**Feedback and Questions on Modeling Portfolios, Scenarios, Sensitivities Associated with  
August 12, 2024 Meeting of the Electric Utility Commission**

**Figure 1 – Frequency of Different Load Zone Price Separation Durations  
in AE Load Zone (vs. Hub Avg) – 2023 Data**

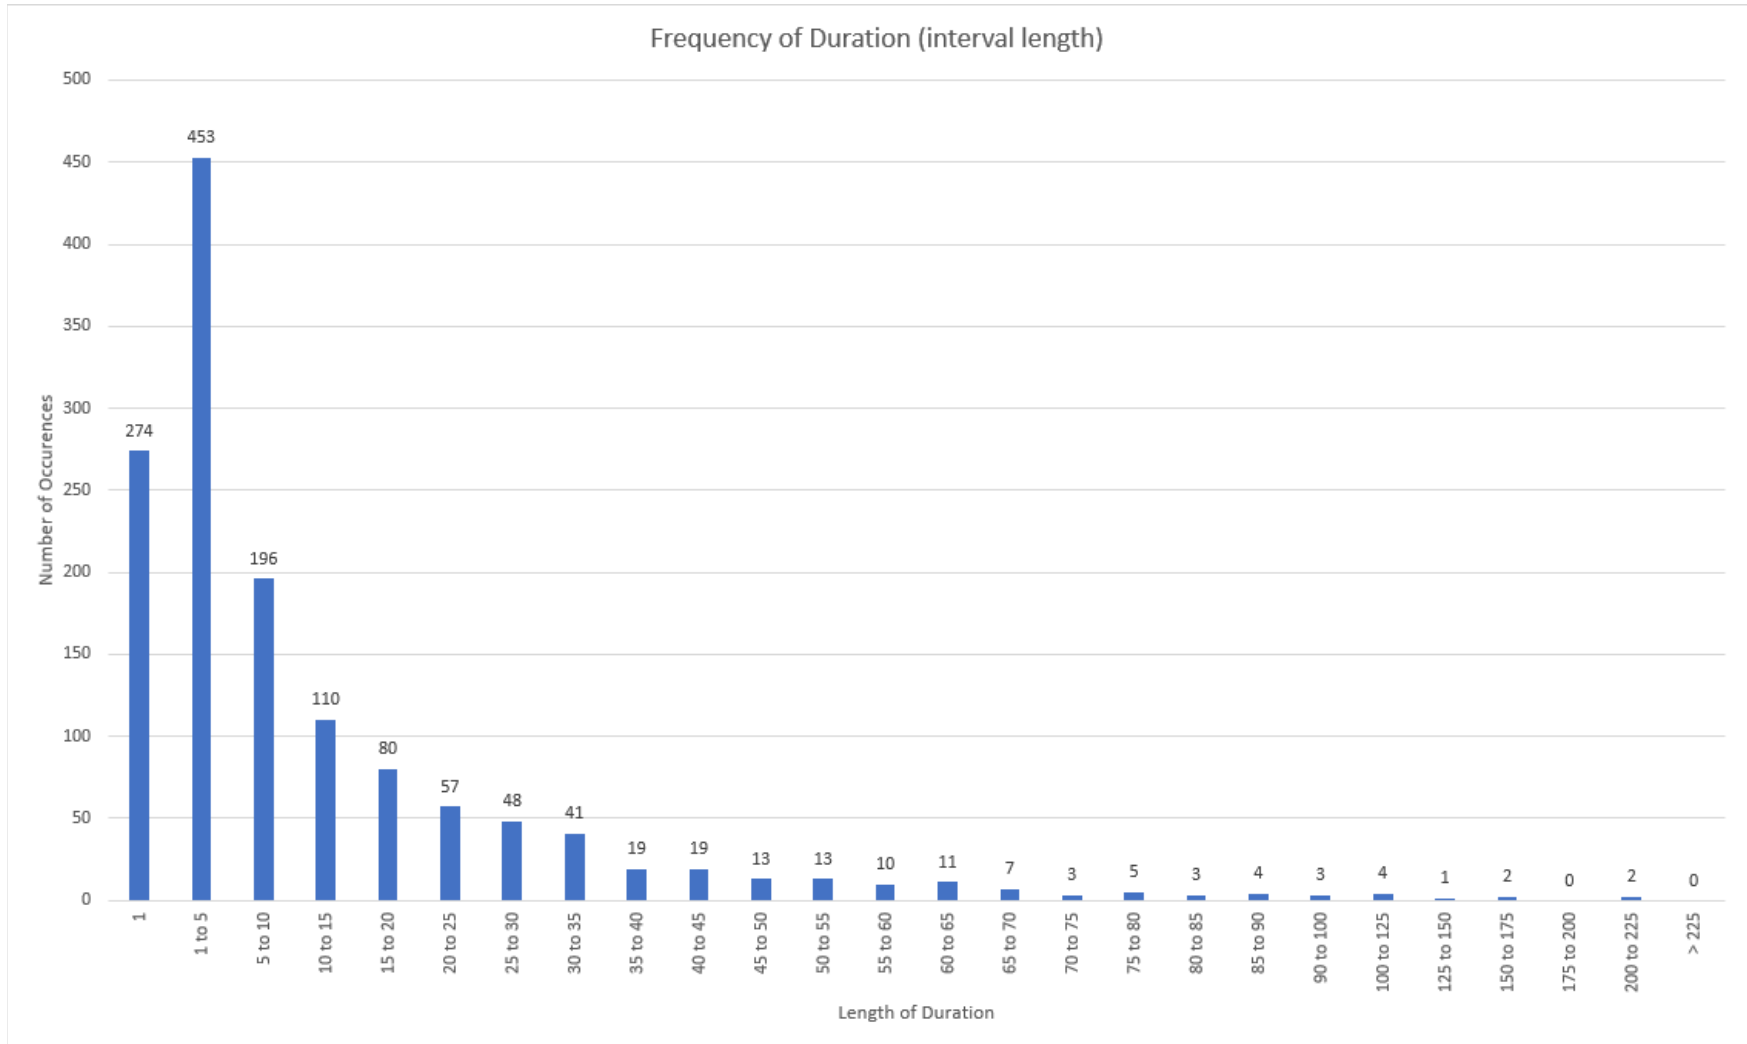
| Commiss-ioner | Question from EUC  | Response from Austin Energy   |
|---------------|--|---|
| Rhodes        | Can you tell me A) how many hours that AE has experienced load pocket price separation, B) what the simple and load-weighted average \$/MWh price differential has been during those hours, and C) BAU expectations for the next 10 years for this issue?  | <p>See Figure 1 at end of this document for data related to duration and frequency of load zone price separation (2023 data).</p> <p>See Table 2 for data related to the frequency of price separation occurrences at different levels of price separation (between AE Load Zone and Hub Average)</p> <p>Austin Energy does not have a good forecast for future expectations as there are many factors that influence power flow, but we see higher probability of occurrence at high load levels so as load continues to grow in Austin and during cold winter events we expect to see this challenge continue and potentially increase.</p> |
